**1120 John Street**

**Onni Group**

**DRB Recommendation Meeting**

**SDCI Project #3030079**

DRB #1 FIN DIAGRAM

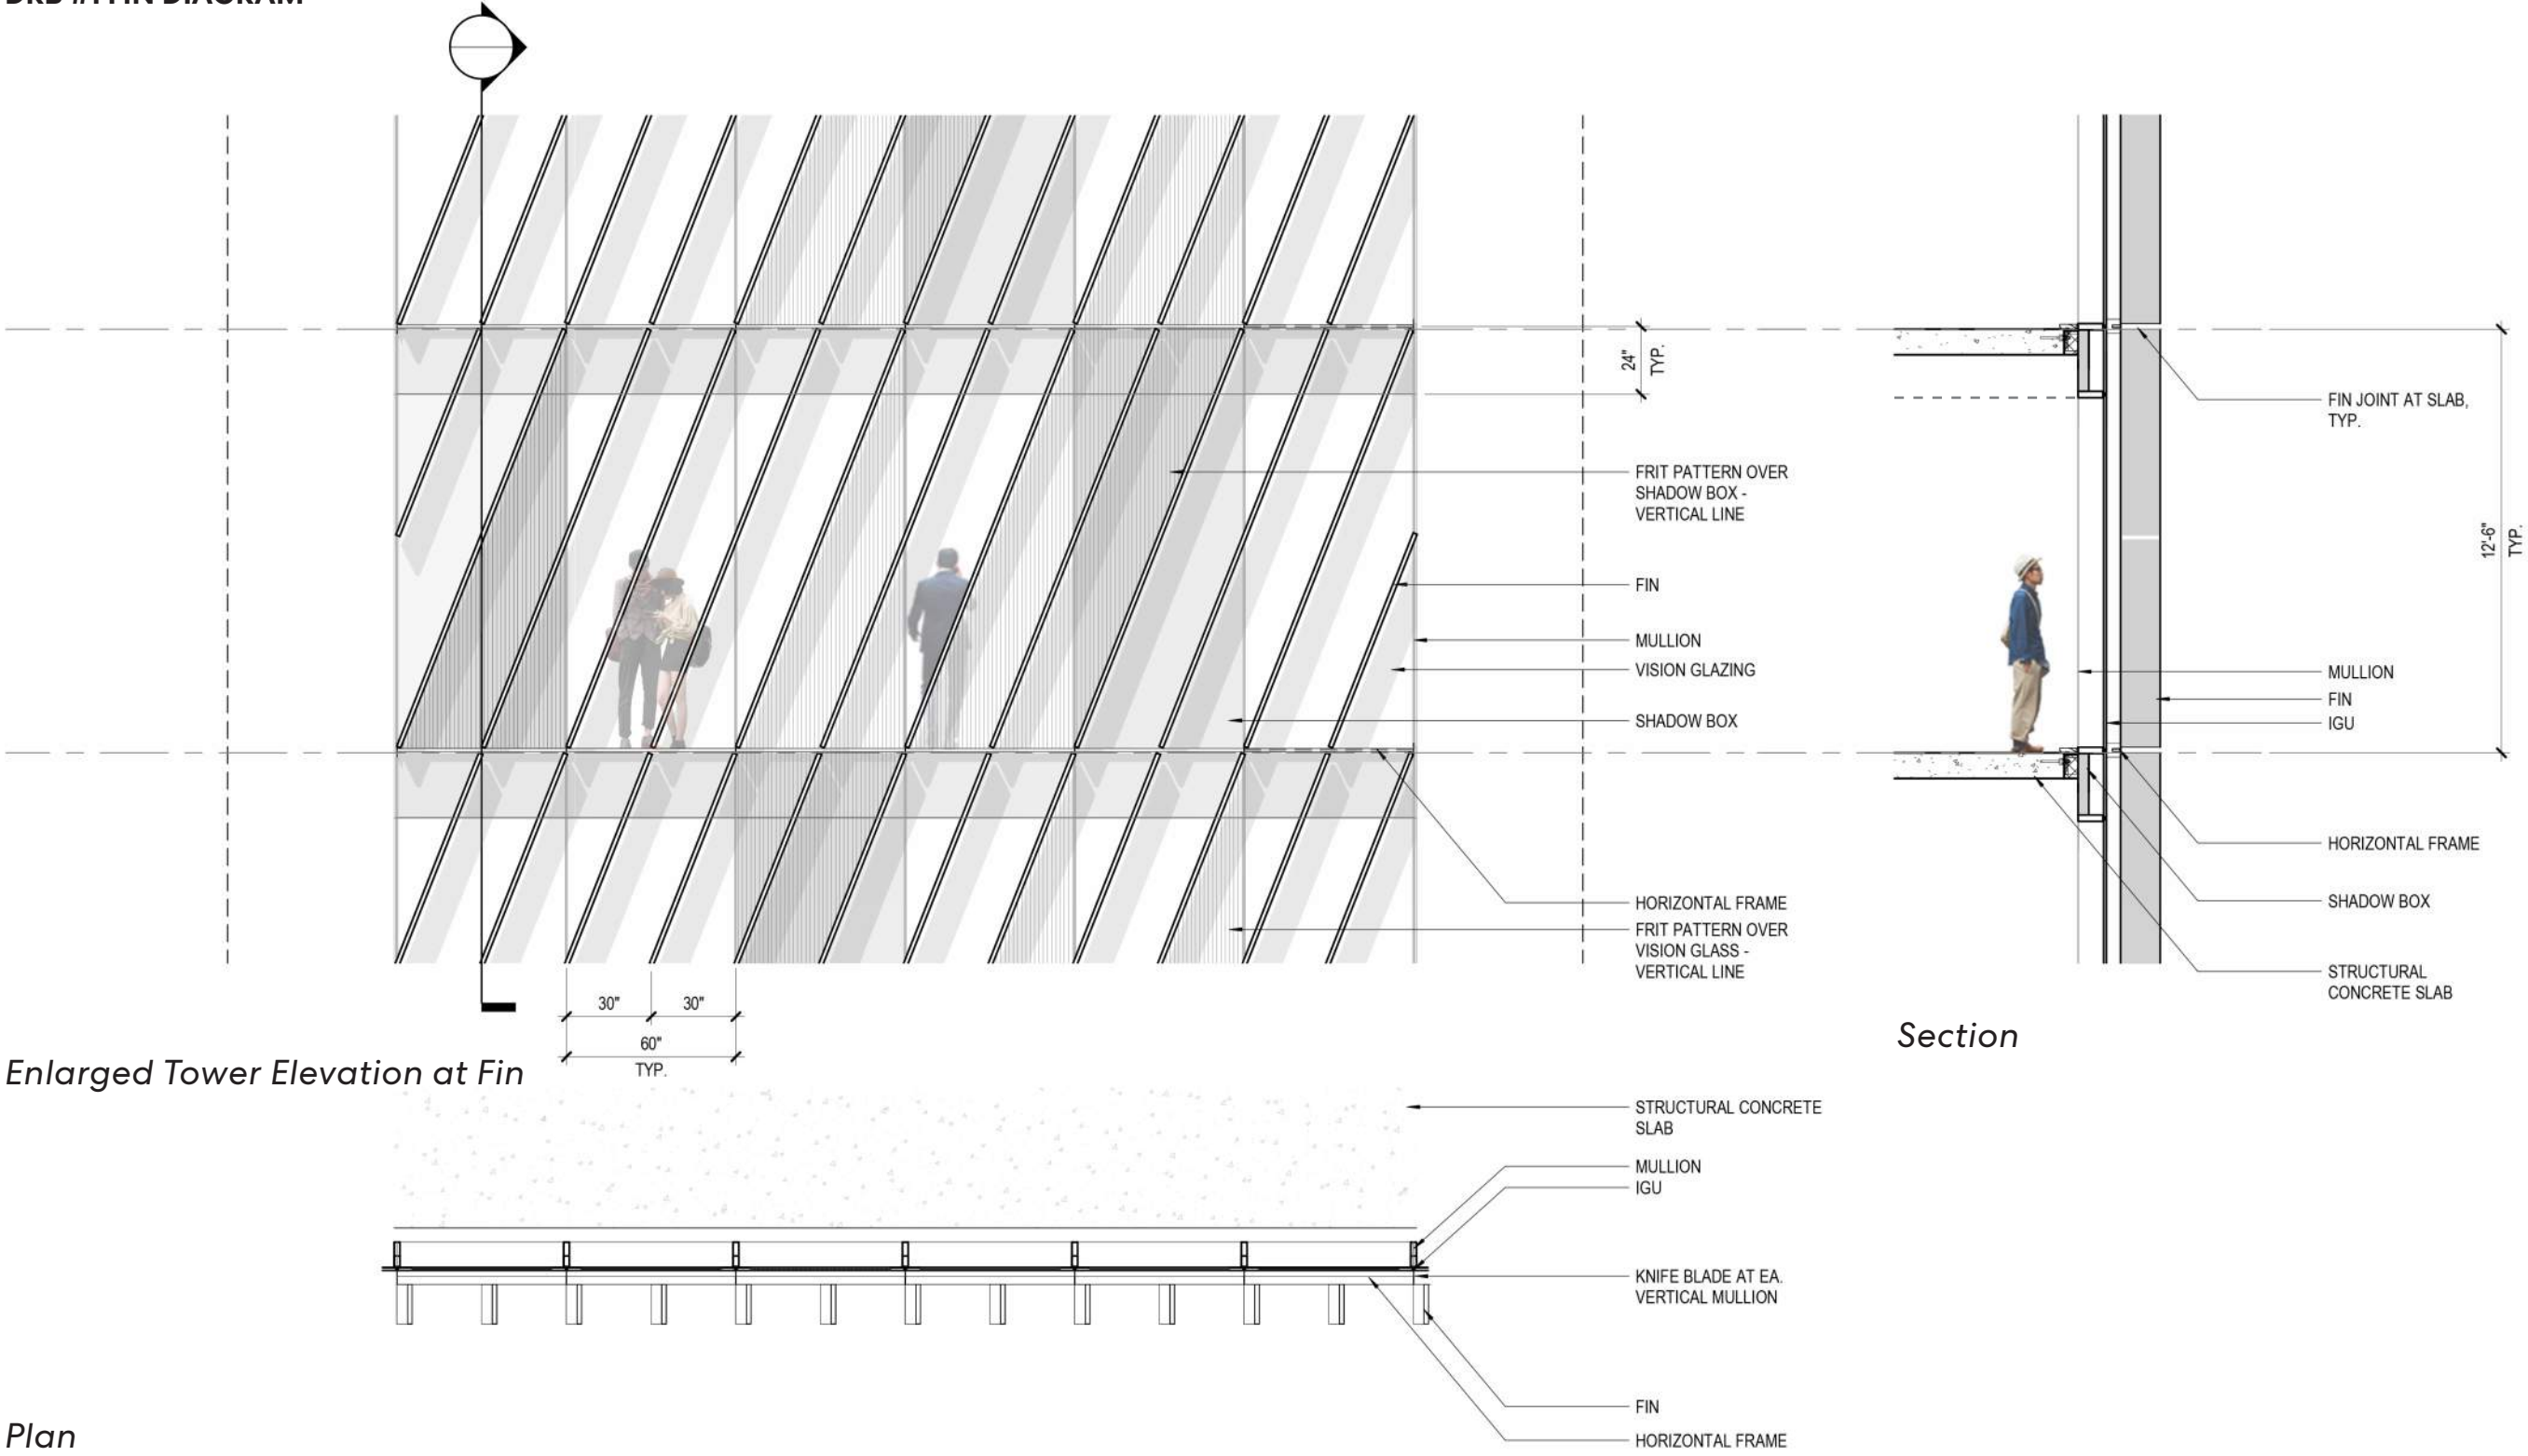
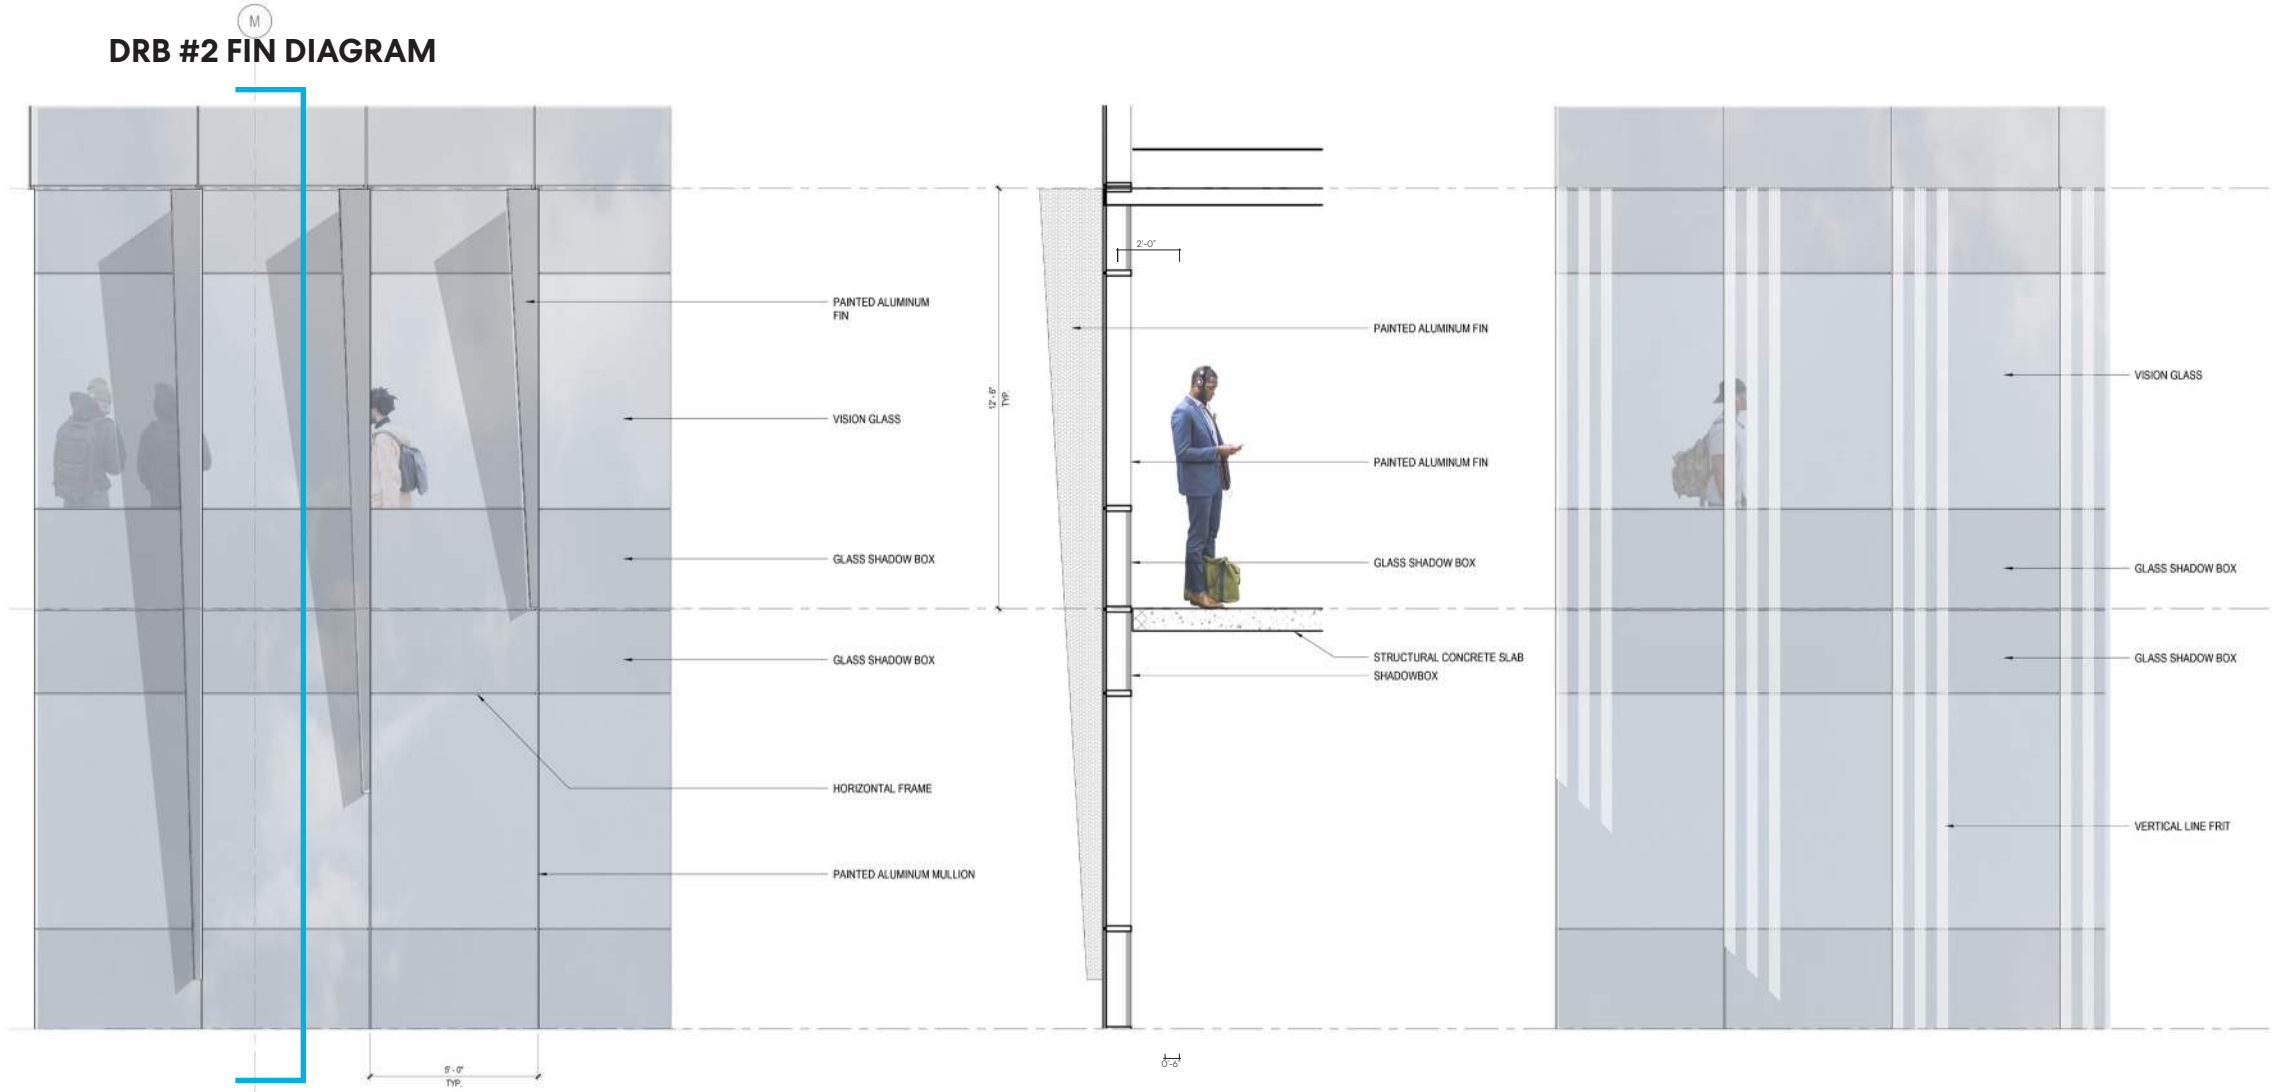
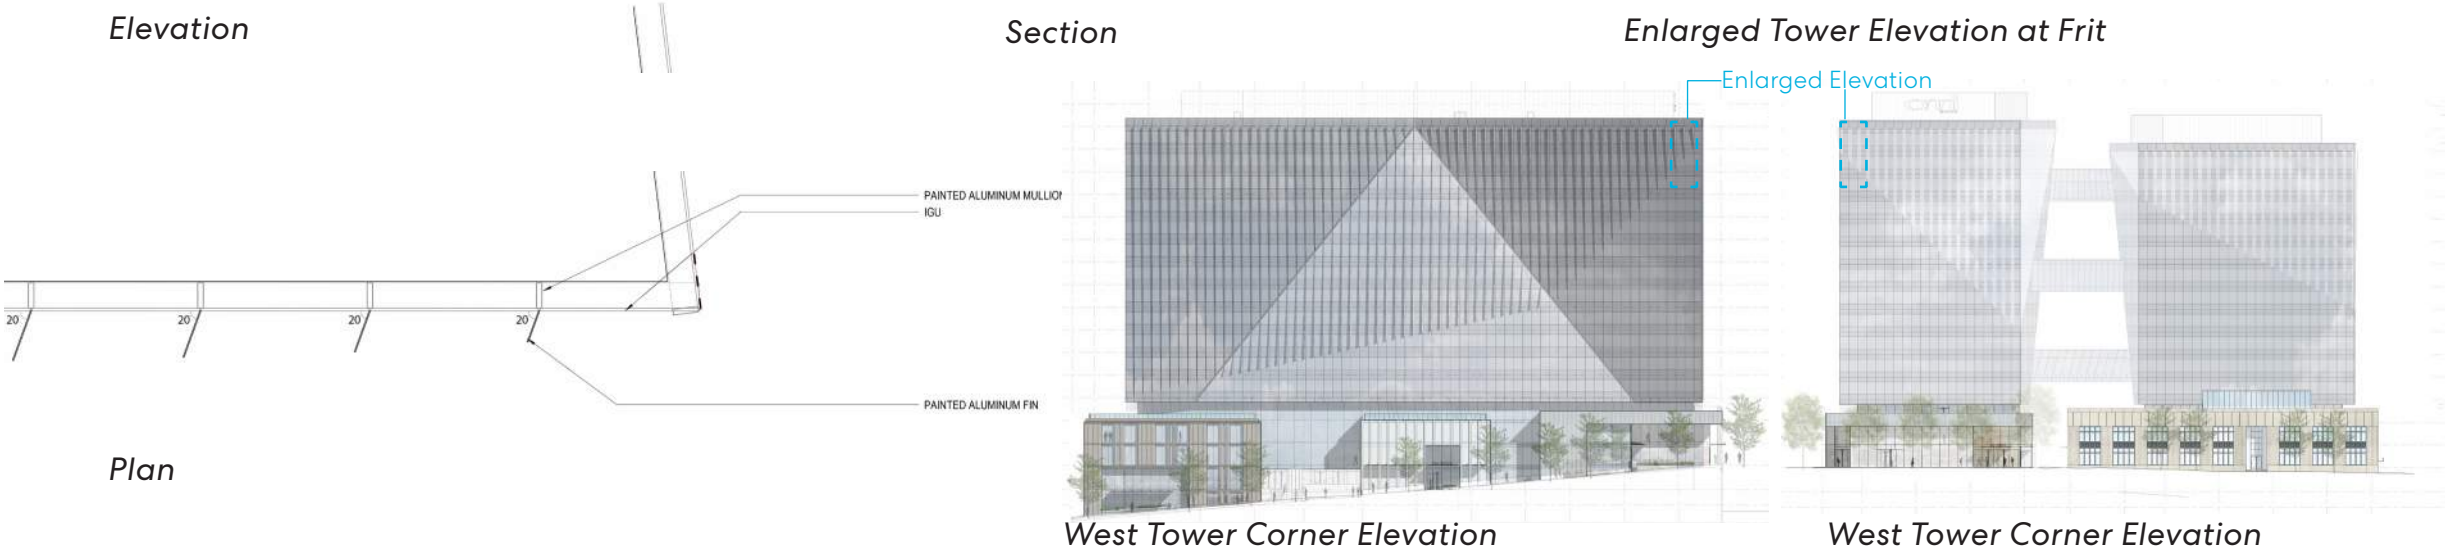
3g. The Board was concerned to hear a description of the revised shape and depth of the proposed fins that was not represented in the recommendation packet drawings. The Board recognized the possibility that those changes could affect the project’s appearance but were unable to comment further on that aspect of the proposal, since the current drawings of those fins were not available for their review. The applicant should be prepared to provide updated drawings and details that correspond to the proposed design at the next recommendation meeting.

To further integrate the fins and frit the design team has simplified the elements to tapering vertical fins and frit creating a continuous geometry around the whole facade. The fins and frit enhance the texture of the towers **(DC2-D-2)** breaking down the faces with finer grain elements. The positioning of these elements create both visual interest but also protect **(CS1-A)** the interior from over exposure to daylight by positioning the fins along the most needed surfaces. Additionally to highlight the modulation of the tower facades, an articulated mullion was placed on the curtain wall fold to create a gap that accentuates the geometry of the facade.

BOREN PLAN AND SECTION AT DRB 1

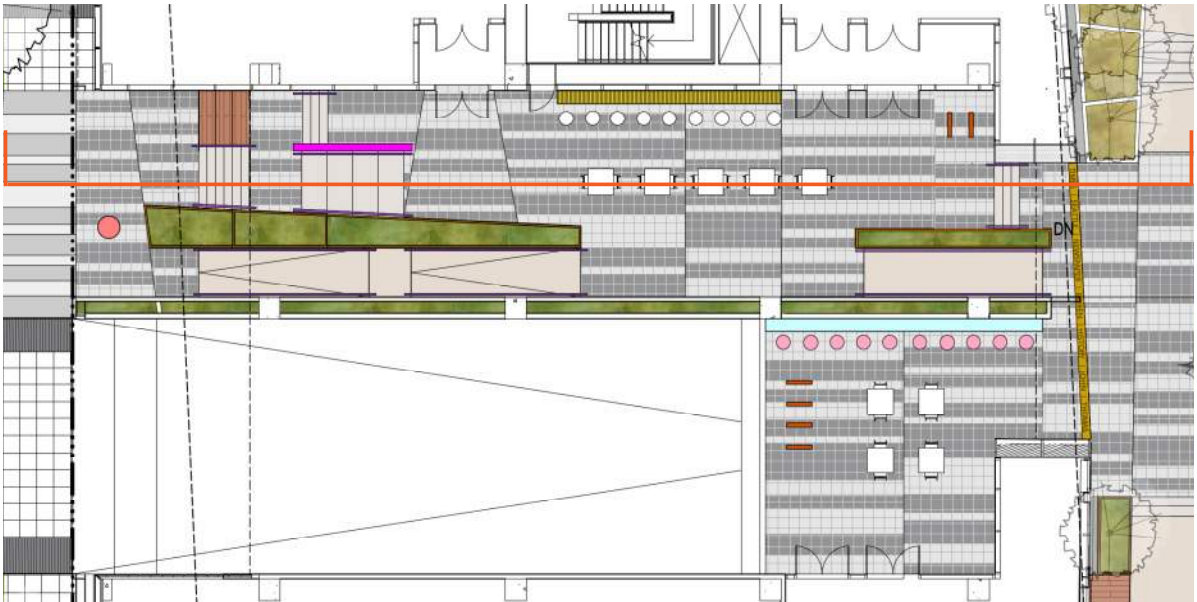
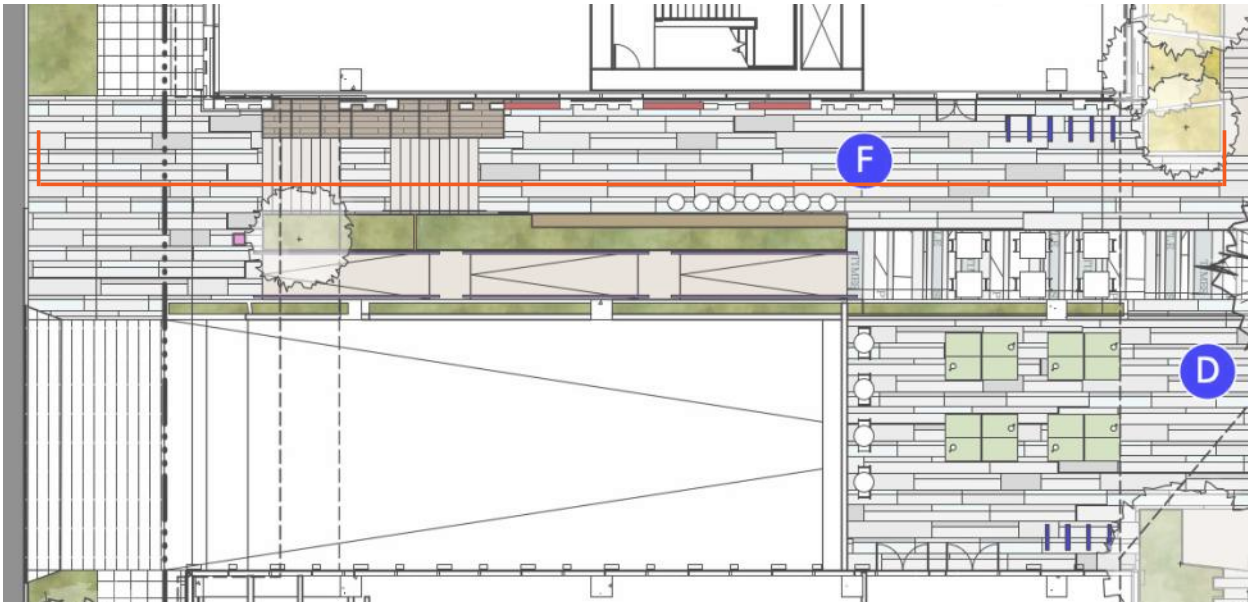
The Board noted that there would be a number of ways to address this issue, but that the most important change would be to increase the size of the view aperture and allow the nature of the Paseo (public, inviting, a usable pedestrian route) to be legible from the street. (CS2-4-c)

- 1 Aperature has been widened by one level to give a wider view into and out of the paseo.
- 2 A small connecting bridge remains in order to provide stair access for tentants on level 03.

- 3 Increased number of stairs at Boren entry to eliminate second set of stairs and ramp at paseo side of Boren entry.
